## WIZARD WORKSHOP ARTICLES

CG 551AP/CG 5001

CG551AP MAINTENANCE INFORMATION  
UPDATE, NEW AND REWORKED INSTRUMENTS  
(REFERENCE PULL-OUT)

Fig. 1

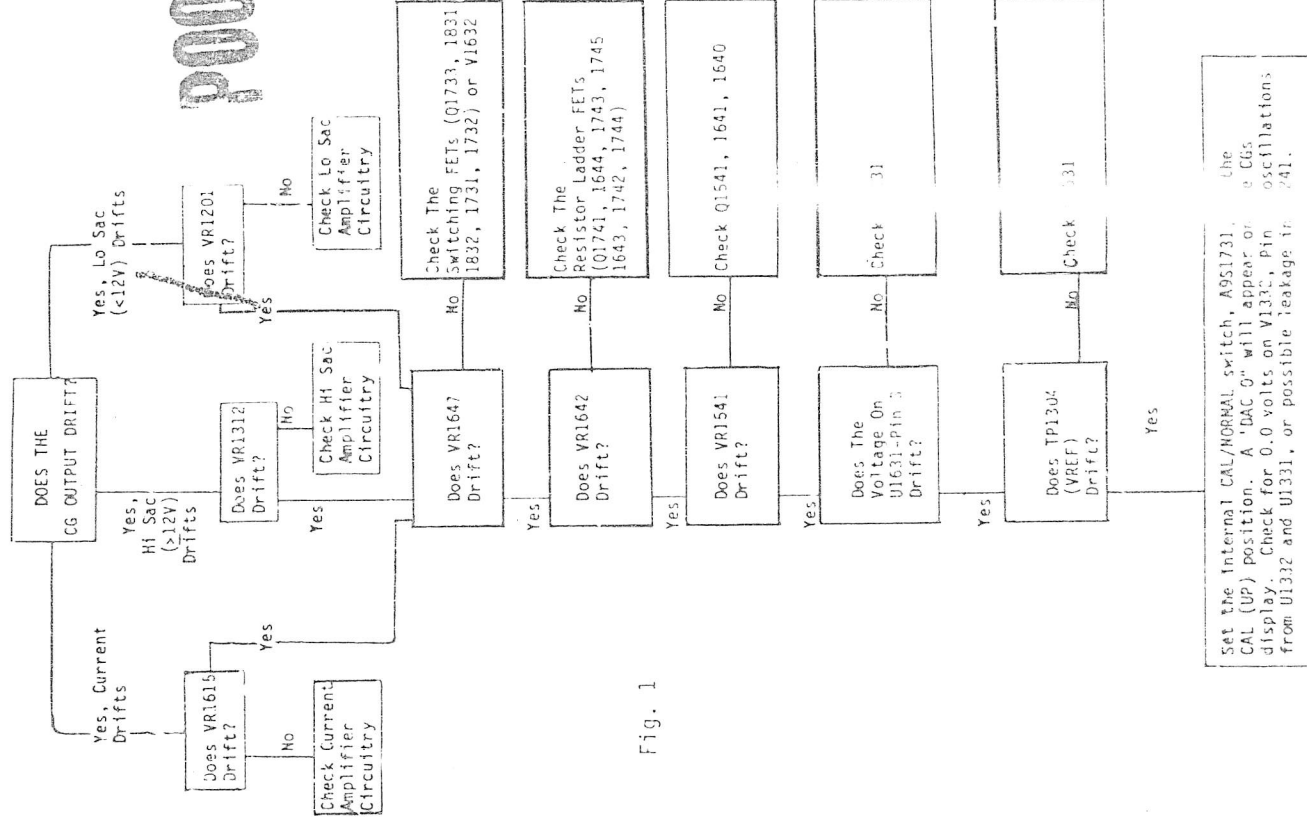
TROUBLESHOOTING FLOWCHART FOR CG551AP DRIFT

In the event of voltage or current output drift problem with the CG551AP, this troubleshooting flowchart will be helpful in the isolation of the faulty components.

To date, the most common cause of output drift has been the resistor ladder FETs which are used only in the cutoff and saturation modes.

The drift occurs when the defective FET is in the cutoff mode, but allows leakage between source and drain. To isolate the leaky FET, one by one remove the FETs that are in the cutoff mode until the drifting stops. (A low on the FET gate will indicate the cutoff mode.)

FIGURE 1  
 (A9) CPU Circuit Board (Back side)  
 Assembly 670-6091-02

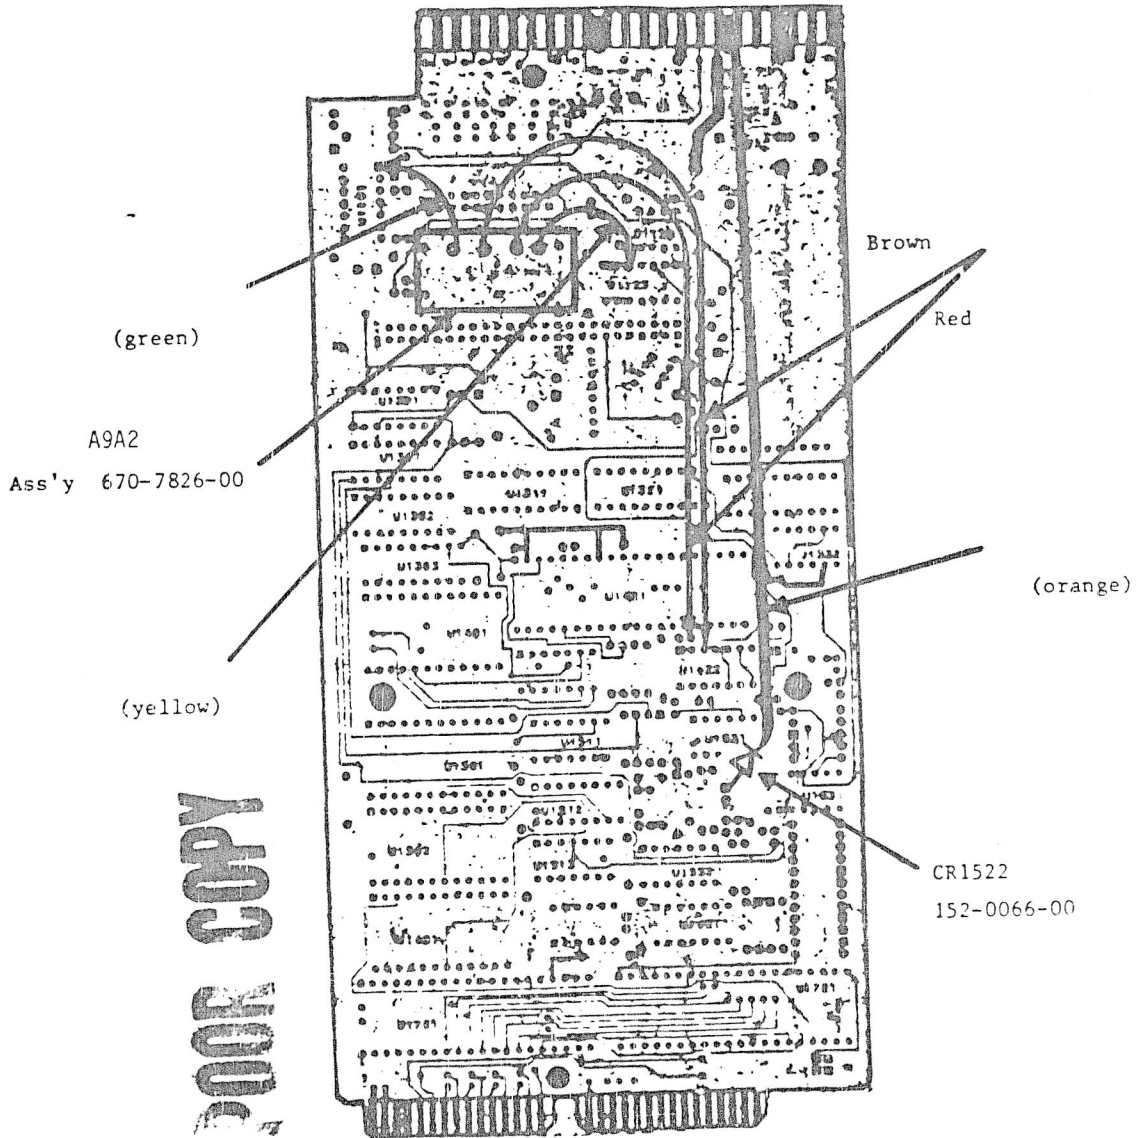
Identification: Reworked instruments can be identified by the residence of a new A9A2 CPU Oscillator board. This board is located on the back of the A9 CPU board, near the edge connector. See Figure 1.

7. Power On/Off Detect circuitry changes with the addition of the new CPU oscillator, changes in the Power On/Off Detect circuitry. Also, for use in a TM5000 mainframe, the PWR signal was coupled to the power On/Off detect. See Figure 5 for Schematic, Figure 1 and 4 for component location.

FIGURE 2

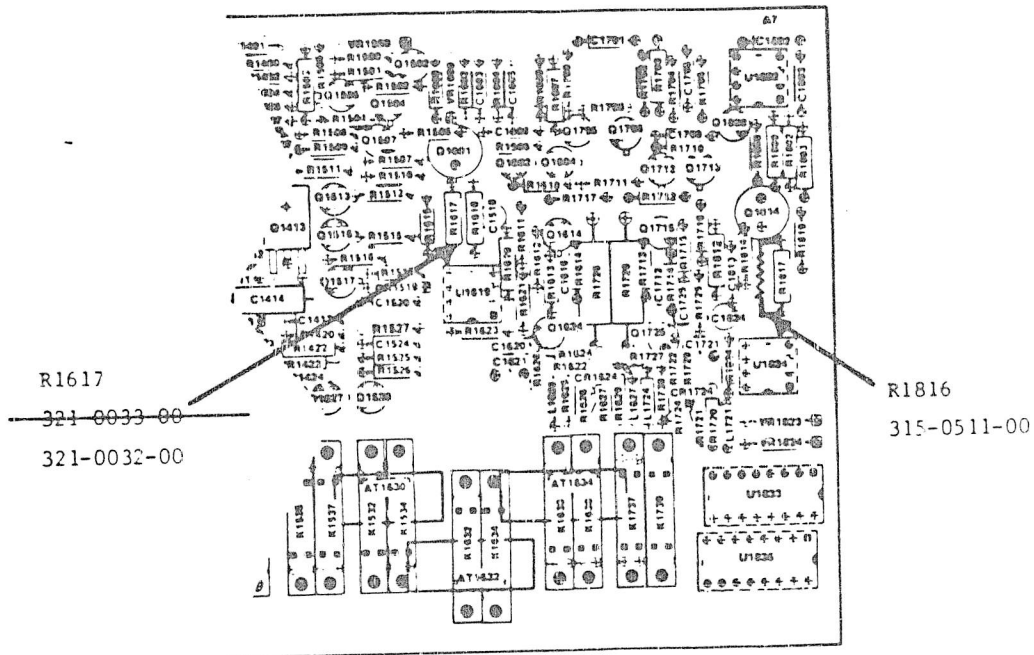
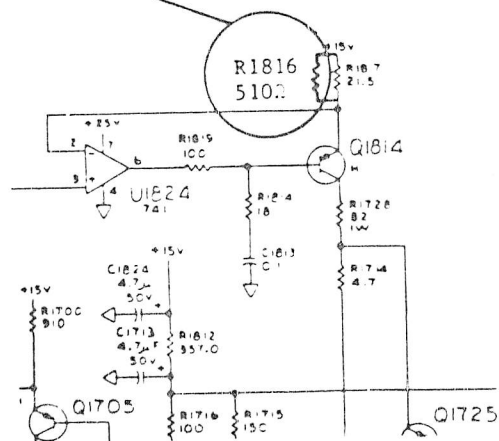
4. Low edge generator calibration constant centering. One resistor was changed and one was added to the low edge generator output to prevent the need for entering large cal constants to center the waveform. See Figure 2.

PARTIAL DIAGRAM 22

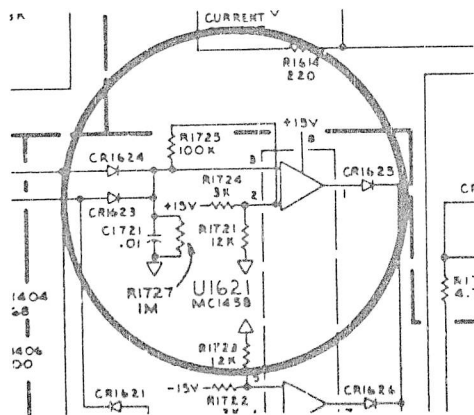
Aberrations in voltage and/or current mode may exceed the  $\pm 15\%$  specifications in some instruments. The problem is best observed in voltage mode, 10V x 1Div, 100 Hz.

- Change Diode A6CR1802 from P/N 152-0141-02 to P/N 152-0536-00.
- Change Diodes A6CR1524 and A6CR1528 from P/N 152-0324-01 to P/N 152-0245-00.
- Lift the end of the 100K ohm resistor, A6R1725 nearest A6R1616, and connect it to the end of A6R1724 nearest A6CR1723.

- Add a new 1 Mohm resistor A6R1727, P/N 315-0105-00 in parallel with A6C1721.

See the partial diagram 22 Schematic for more detail.

DIAGRAM 21 PRECISION DIVIDER-A6  
V-I CONVERTER-A6

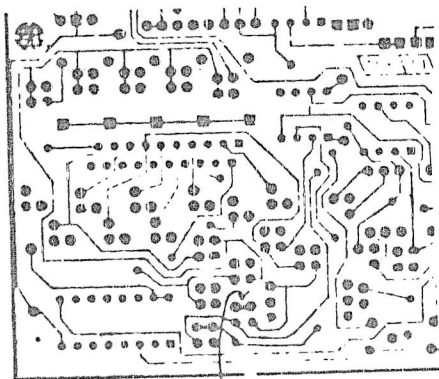
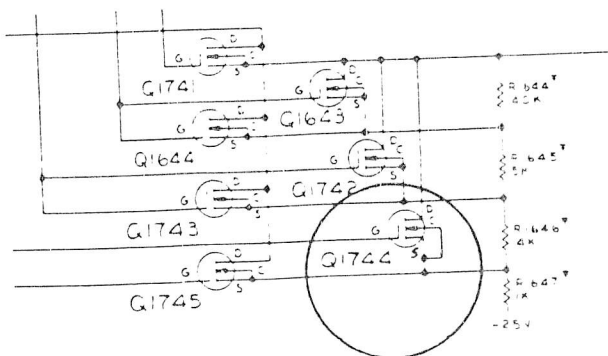
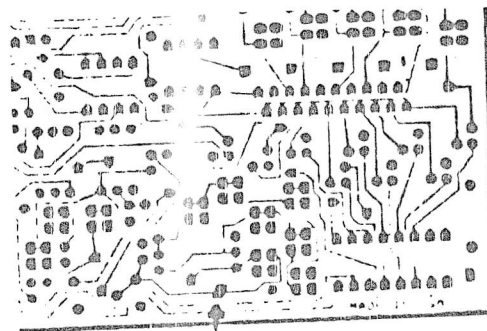
The internal source (S) to substrate (C)  
breakdown voltage for 151-1098-00 has  
been lowered to 7V by the vendor. The  
configuration of A6Q1744 exceeds this  
specification and should be modified to  
maintain good reliability.

An FET in location Q1744 which has had  
its source to substrate voltage exceeded  
will become leaky. When Q1744 has  
leakage, the CG may show Error Codes  
51,54,81,83,87, as well as 1V and 10V  
amplitudes reading out of tolerance.

On the component side of the board, cut  
the run at Q1744 which leads to C1641. A  
good place for cutting the run can be  
found under the lead of R1647 closest to  
the rear of the board. On the backside  
of the board, add a 26 AWG bare wire  
strap that connects the "S" lead to the  
"C" lead. This modification makes the  
configuration of Q1744 identical to the  
rest of the FETs in the V to I Converter.

CHANGE—the connection of the collector of Q1744 (location J8)  
as shown below:

ADD #26 BARE WIRE

CG551AP/CG5001 CPU POWER SUPPLY  
PROTECTION IMPROVED

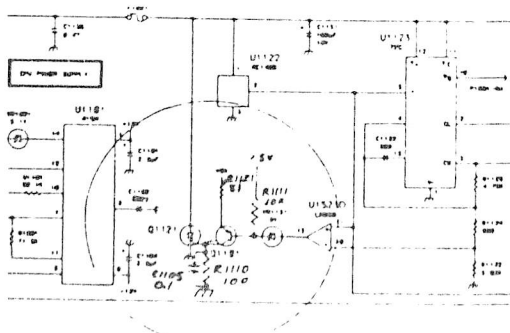
To be certain that the crowbar circuit  
will fire consistently when an  
overvoltage situation occurs on the  
+5V CPU supply, several parts were  
changed and added.

1. On the back of the A9 CPU board  
locate the connections for the SCR,  
Q1121.
2. Add a parallel combination  
consisting of a new 100 OHM  
resistor, R1110 PN 315-0101-00 and  
a new 0.1uf capacitor, C1105 PN  
281-0775-00 between the gate and  
the cathode of Q1121. (The outside  
leads) Be sure to dress these  
parts toward the front of the board  
to allow clearance for the rear  
panel.
3. On the front of the board, change  
R1121 to a 51 OHM resistor, PN  
315-0510-00.
4. Also on the front of the board, add  
a new 10K OHM resistor, PN 315-0103-00  
from the cathode of VR1131 to the +5V  
side of R1121. See the revised  
schematic below for details.

REF: A7 Output board  
All serial numbers.

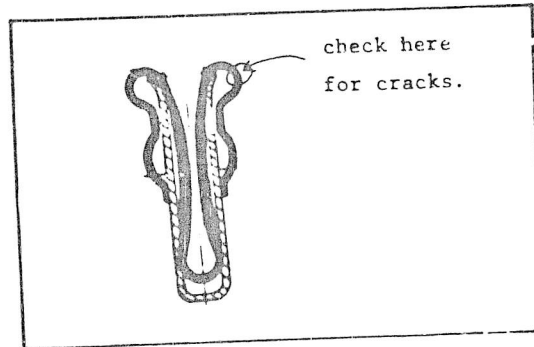
A reliability problem has been discovered with the Berg sockets used under the magnetic latch relays on the output board of the CG551AP/5001. Many of these sockets were installed incorrectly, causing intermittent operation of the relays. Some of the sockets have broken solder joints or lifted circuit board solder pads, and some of the sockets themselves are damaged.

The broken solder joints and lifted solder pads can be observed and repaired from the bottom of the board. The relays must be removed to check for damaged Berg sockets. Using the highest magnification available, a microscope if possible and a strong light, examine the sockets for fractures in the areas indicated on the drawing. All damaged sockets must be replaced.

When replacing these sockets, it is suggested that adhesive tape be applied over the gold relay contact pads to prevent solder from adhering to the contact areas. Use a thin, stiff wire, such as a straight pin, to insert the new Berg sockets into the holes. Do not apply force to the top of the socket, as this will damage it. After replacing all the damaged sockets, remove the adhesive tape and clean the contact areas with isopropyl alcohol.

Figure 1.0  
Partial view, A9 CKT. Bd.  
(Back Side)

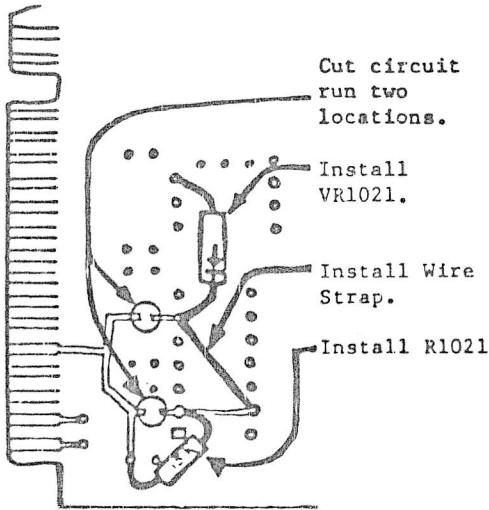
The modification (M60339) will suppress negative spikes caused by the 015-0311-00 Programmable Pulse Head. Typically, the only time these spikes occur is when the Pulse Head is installed after the CG is powered-up. These spikes, without this modification, will cause the CG to initiate self-test.

The modification consist of a clamp circuit at the input of A9U1021. It is comprised of adding A9R1021 (P/N 315-0153-00) and A9VR1021 (P/N 152-0175-00) on the backside of the A9 (CPU) circuit board (see figure 1.0). The schematic drawing changes are indicated in Figure 2.0.

Figure 2.0

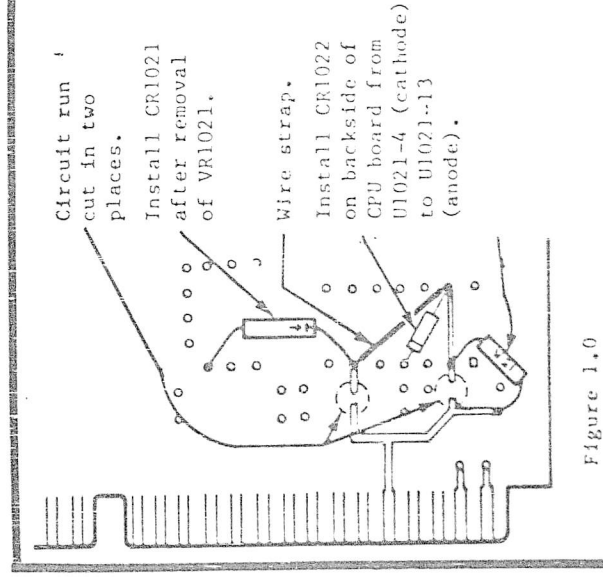
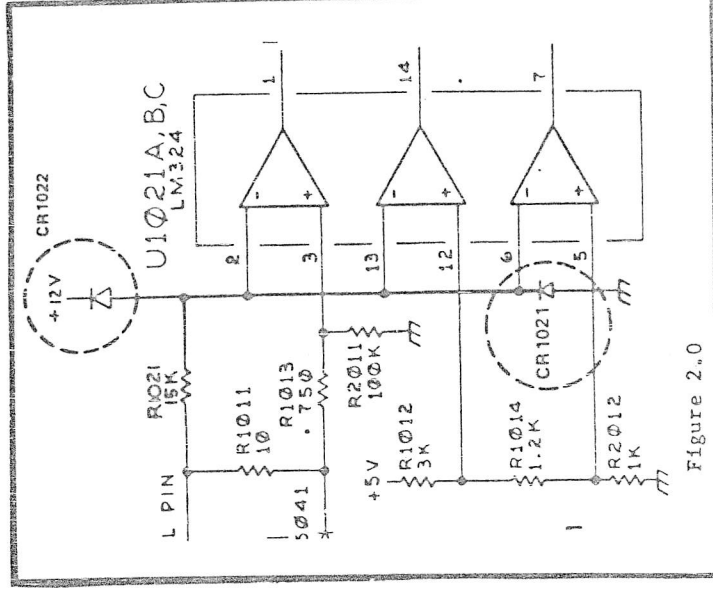
When this modification is installed, using Zener diode Tektronix P/N 152-0175-00, an operator discrepancy is noted. The discrepancy appears when the Pulse Head is not installed on the CG. The operator is able to program the Fast Edge Mode from the front panel without receiving an "Entry Error" message. Also, when the Pulse Head is attached to a powered-up CG it is not being sensed, therefore causing no CG relay action to occur. These are the only discrepancies that occur as a result of installing Zener diode VR1021.

To correct this, remove VR1021 and install CR1021 (Tektronix P/N 152-0141-02) in its place. Also install CR1022 (Tektronix P/N 152-0141-02) on the backside of CPU board from U1021-4 (cathode) to U1021-13 (anode). Figure 1.0 shows the parts orientation on the backside of the CPU board. Figure 2.0 indicates the schematic changes.
